MIL-M-28787/286
AMENDMENT 3
30 July 1993
SUPERSEDING
AMENDMENT 2
23 September 1983

MILITARY SPECIFICATION

MODULES, STANDARD ELECTRONIC

MEMORY, RANDOM ACCESS, DIGITAL, KEY CODE KYF

FIGURE 16. Input clamp diode voltage test circuit for table VIII.

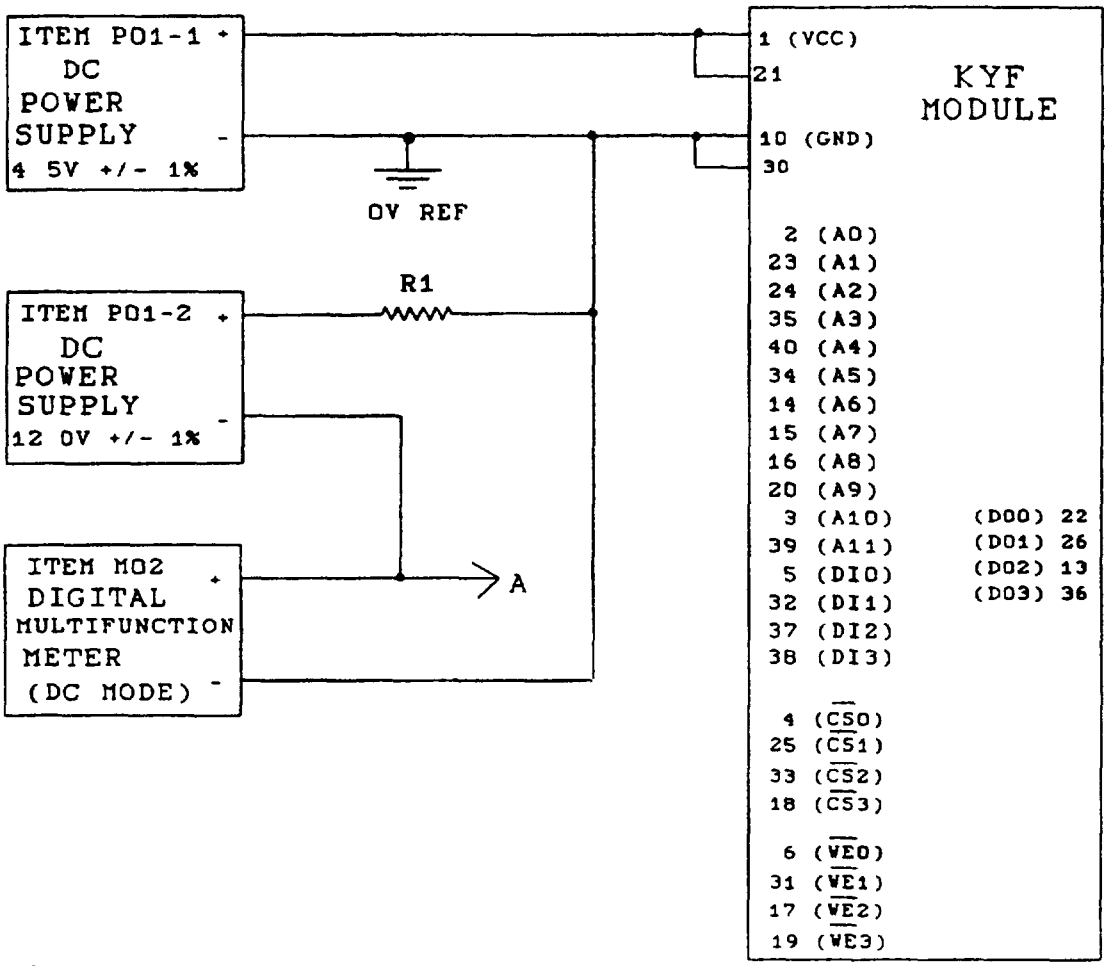
FIGURE 16: Delete and substitute new figure 16 as printed on page 5 of this amendment.

NOTE: R1 = 887Ω ± 1%, 1/4 W.

FIGURE 17. Static output voltage (low-level and high-level) test circuit for table IX.

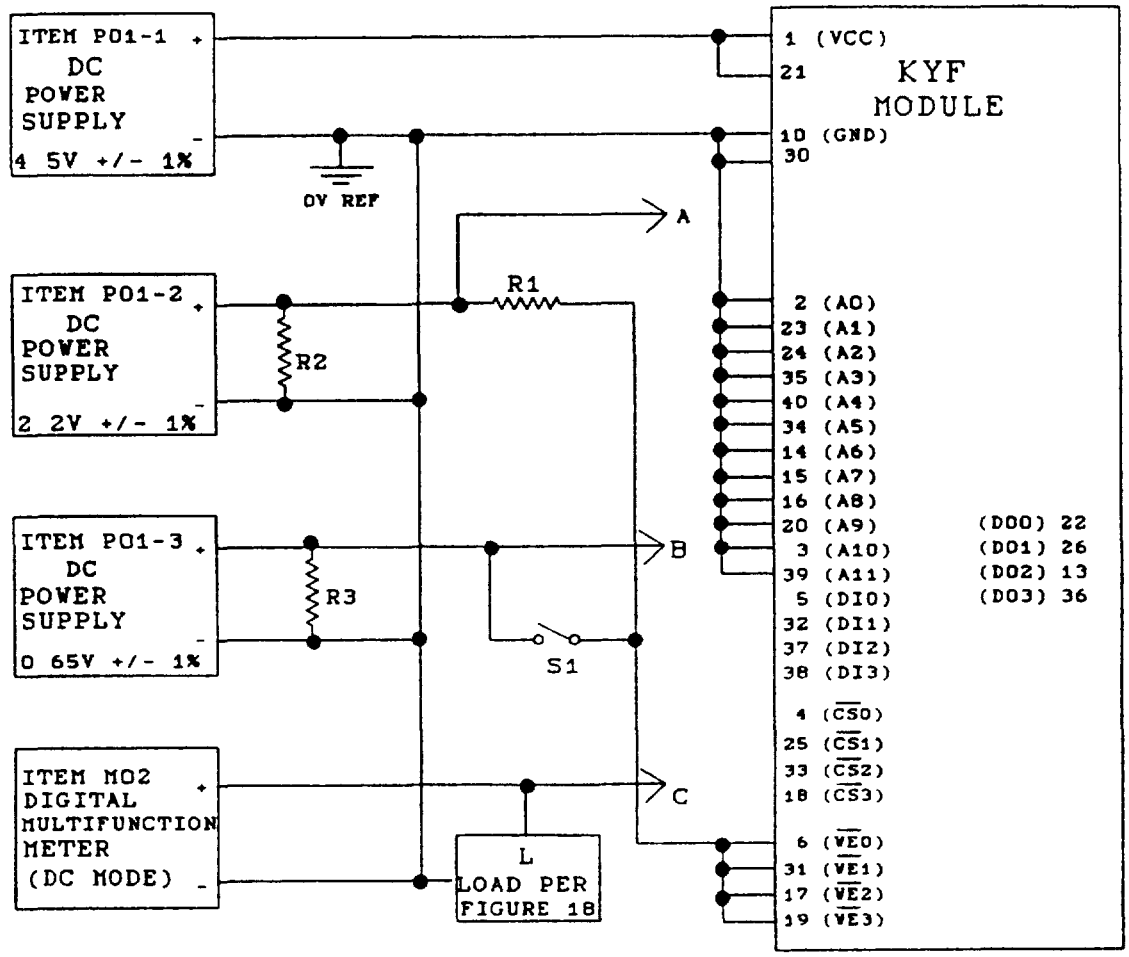
FIGURE 17: Delete and substitute new figure 17 as printed on page 6 of this amendment.

NOTES:
1. R1 = 1.2 kΩ ± 5%, 1/8 W.
2. R2, R3 = 51Ω ± 5%, 1/2 W.
3. Close switch S1 for 500 ns minimum, then reopen before making measurements.
4. After VCC has been applied, do not remove it until test is complete.
5. S1 = SPST.

FIGURE 21. Address input threshold check (low-level and high-level) test circuit for table XII.

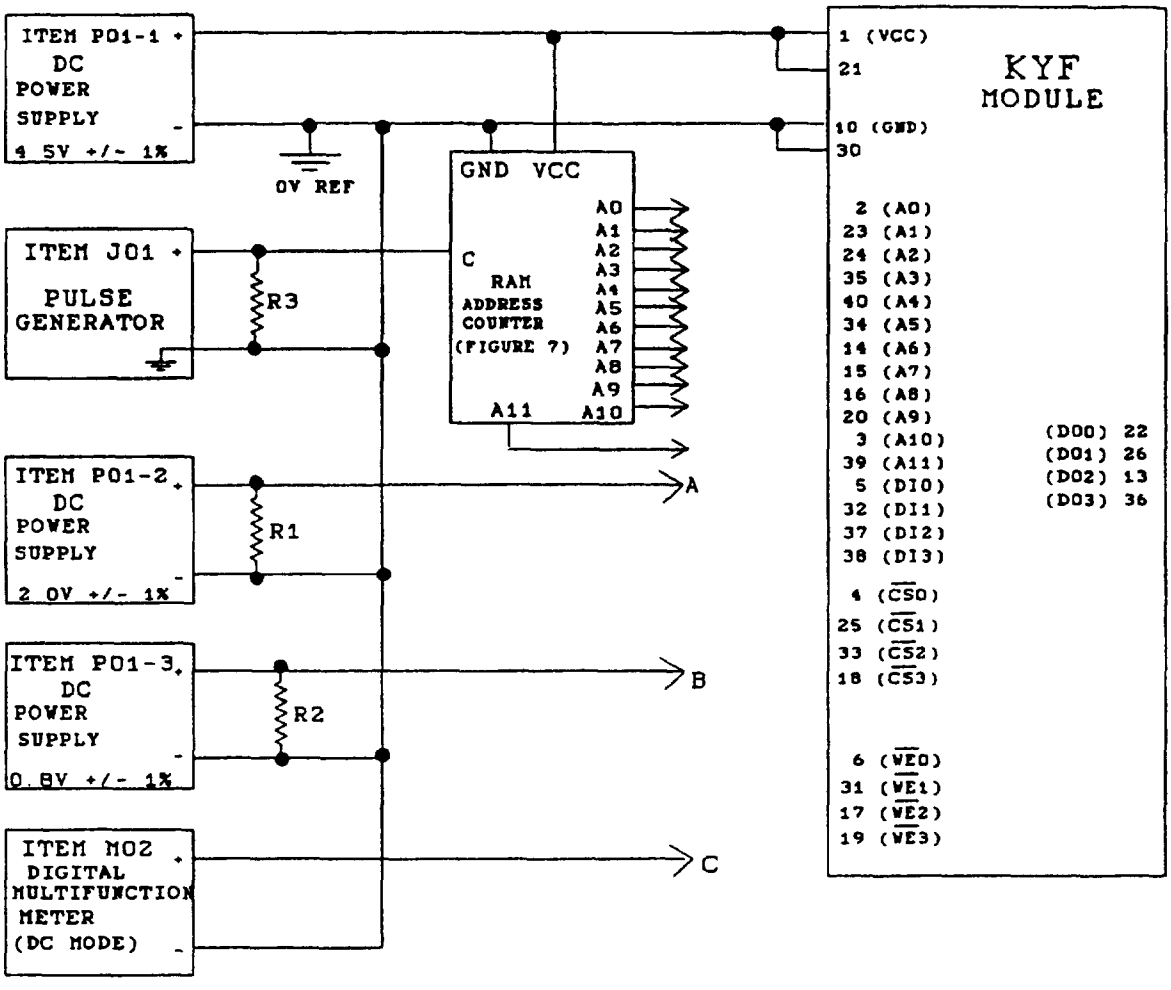
FIGURE 21: Delete and substitute new figure 21 as printed on page 7 of this amendment. (Notes for figure 21 printed on page 49 are not to be deleted).

FIGURE 28. Dynamic test circuit for table XVII.

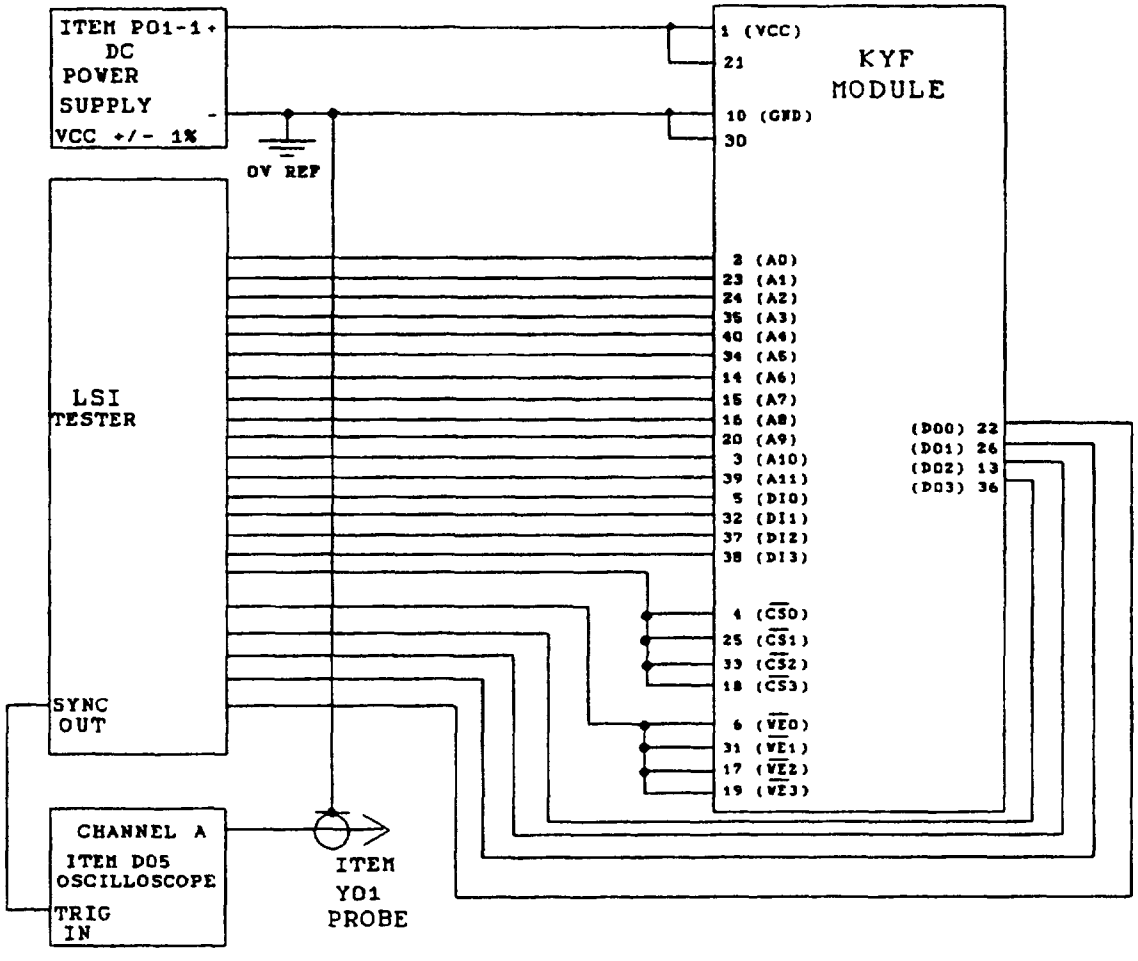
FIGURE 28: Delete and substitute new figure 28 as printed on page 9 of this amendment.

1. VCC = 4.5V ± 1% for test conditions S1, S3, S5, S7, S9 and S11.
2. VCC = 5.5V ± 1% for test conditions S2, S4, S6, S8, S10 and S12.
3. Load output pins 13, 22, 26 and 36 with load as specified on figure 18 with CL = 50 pF for test conditions S1-S6.
4. Load output pins 13, 22, 26 and 36 with load as specified on figure 18 with CL = 150 pF for test conditions S7-S12.
